SUBMITTAL SUMMARY REPORT 33553

PLAN NAME:	TARGET OF OCALA	LOCATION:	9479 SW 80TH AVE OCALA,
APPLICATION DATE:	10/29/2025	PARCEL:	35300-000-16
DESCRIPTION:

OCE: Plan Review (DR) v.4

C404
CIVIL SHEET 10 OF 41

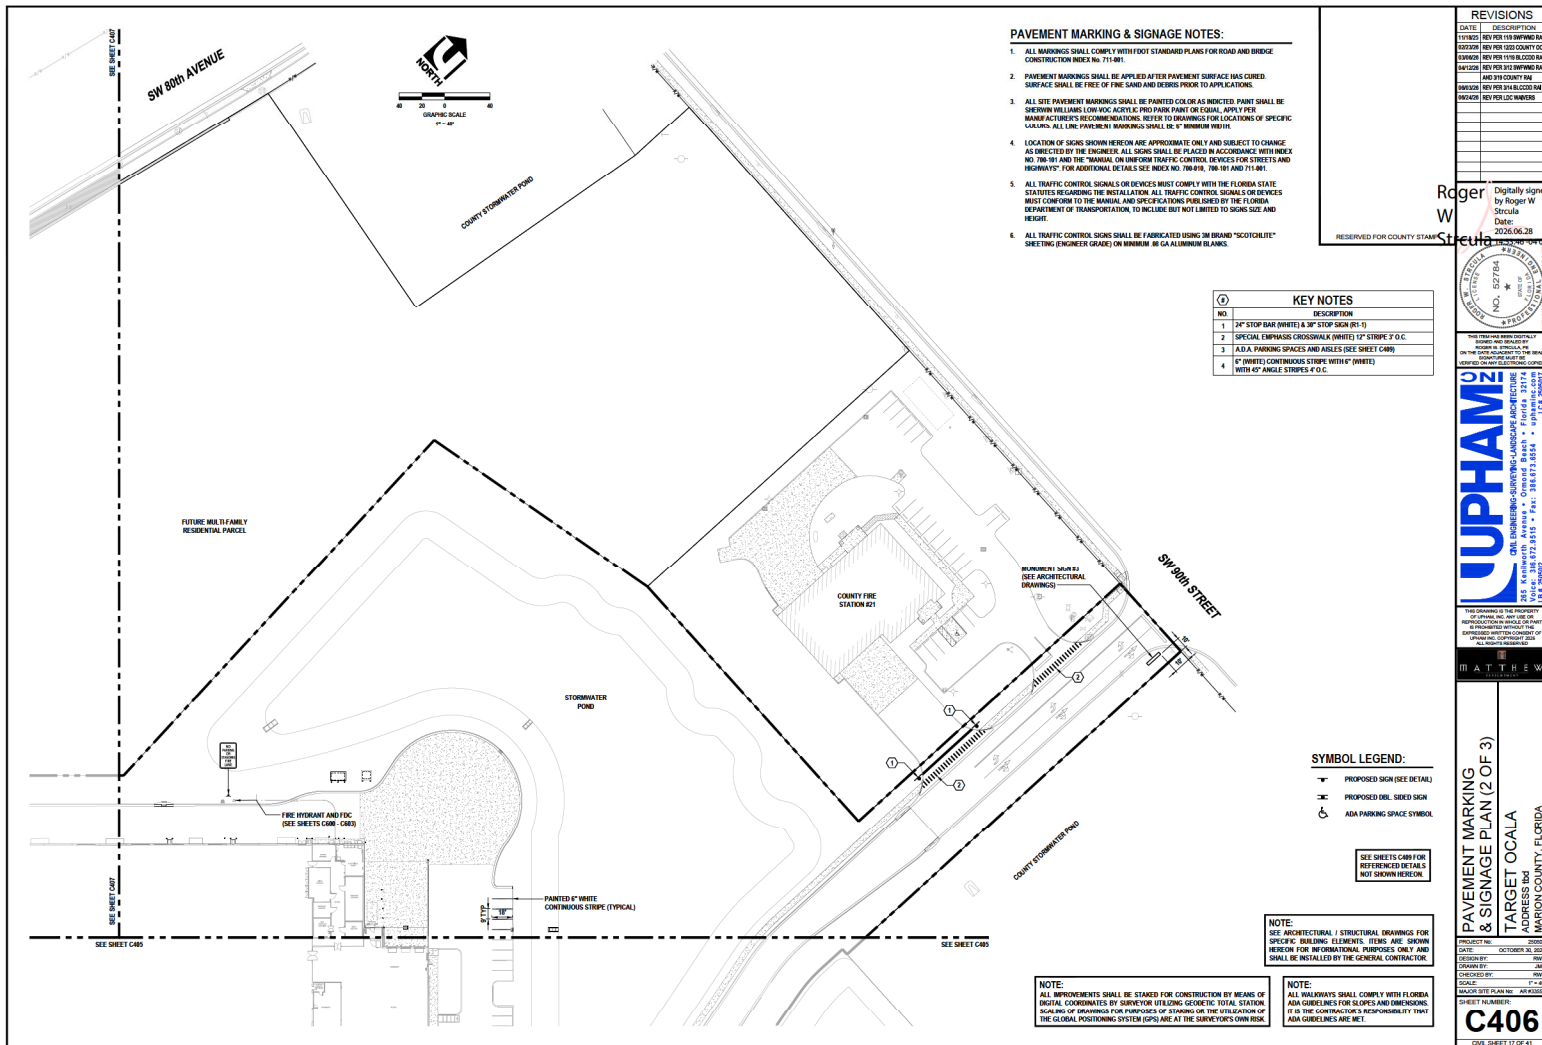
Corrections	6.11.9.B - Traffic signs (Resolved) - Corrective Action: Provide a minimum 30"x30" stop sign at the driveway connection to SW 80th Avenue. - 6.11.9.B - Traffic signs: Provide traffic signs as required in Section 6.11.9.B.			
Corrections	6.11.5 - Driveway access (Resolved) - Corrective Action: A full review of the driveway locations and level of access will be completed when the traffic study is submitted for review. - 6.11.5 - Driveway access: The driveways must meet the requirements of section 6.11.5.			
Corrections	6.11.3 - Traffic Impact Analysis (Resolved) - Corrective Action: 11/21/25 - A traffic study is required. A traffic methodology has been approved. The traffic study must be submitted and reviewed as a separate application from the site plan. Please submit the traffic study under an application for Traffic Impact Analysis -Traffic Study. - 6.11.3 - Traffic Impact Analysis: Provide a Traffic Impact Analysis
